# Access Compliance Report

## Public Rights-of-Way

### (Curb Ramps)

Intersection ID: 10025368	Main Street: E_8TH_ST	Cross Street: N BREVARD ST	Location: W
ADA ID: 12575D55C121	Ramp Type: BlendTrans1	Initial Pass/Fail: Pass	Overall Compliance: No
Severity Score: 15			
Codes/Mitigation Info/Possible Solution		Field Measurements/Component Compliance

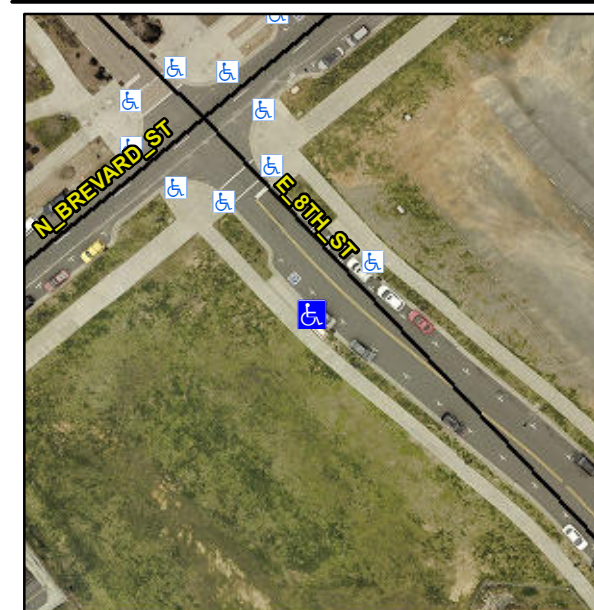
**ACCESS AISLE RAMP**

**R304.2.2-Perp, R304.3.2-Para, R304.5.3, R304.2.3, R305, R304.5.4**

Compliance	Description	Data	Compliance	Description	Data
N/A	Ramp Length (in)	73.0	Yes	BlendTrans Slope (%)	1.7
Yes	Ramp Width (in)	60.0	Yes	BlendTrans XSlope (%)	1.3
Yes	Flare Type	Curbed_NoWalkSurface	No	Flare Type	Curbed_WithWalkSurface
N/A	Flare Slope LT (%)	N/A	N/A	Flare Slope RT (%)	N/A
N/A	Flare Traversable LT?	No	N/A	Flare Traversable RT?	No
Yes	Landing Length (in)	59.0	No	DWS Provided?	No
Yes	Landing Width (in)	71.0	N/A	DWS Contrast?	No
No	Landing Slope (%)	3.7	N/A	DWS Length (in)	N/A
No	Landing X Slope (%)	2.1	N/A	DWS Full Width?	No
N/A	Landing Curb? (Y/N)	No	N/A	DWS Offset (in)	N/A
N/A	Shared Landing?	No			
Yes	Gutter Ponding?	No	No	Gutter Slope (%)	N/A
Yes	Gutter Lip Ht (in)	0.0	No	Gutter X Slope (%)	N/A
N/A	Painted X Walk1?	No	N/A	Painted X Walk2?	N/A
	X Walk 1 Direction	To NE		X Walk 2 Direction	N/A
	X Walk 1 Width (in)	N/A		X Walk 2 Width (in)	N/A
	X Walk 1 Slope (%)	2.7		X Walk 2 Slope (%)	N/A

X Walk 1 X Slope (%)	1.0		X Walk 2 X Slope (%)	N/A
N/A	Ramp inside XWalk1?	N/A	N/A	Ramp inside XWalk2?	N/A
	Road Slope (%)	1.0		Clear Space?	Yes
	Road X Slope (%)	2.7	N/A	Clear Space to XWalk (in)	N/A
Yes	Any Obstructions?	No	Yes	Storm Grate/Utility Hazard?	No
	Obstruction Type			Storm Grate/Utility Type	
		N/A			N/A
			Yes	Surface Condition? (G/P)	Good
			Yes	Curb Slope (%)	0.8

**Remove & Replace Curb Ramp With Two New Directional Ramps or Equivalent. Remove & Replace Gutter.**
